ADA Curb Ramp New Construction Inspection Form (Perpendicular)

Nw King

23885.56

Nw 292

PERPENDICULAR RAMP (PR)

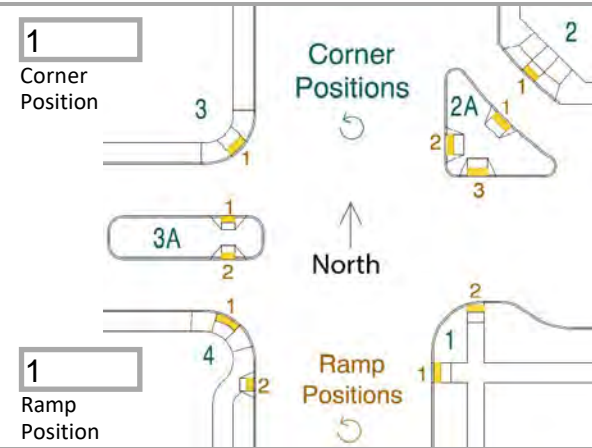
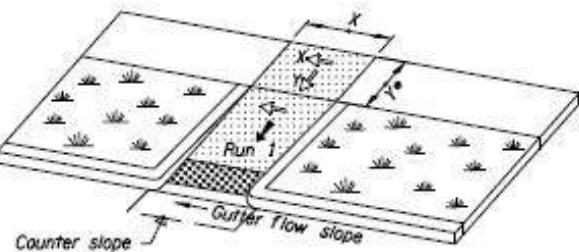
Tool joint in TS
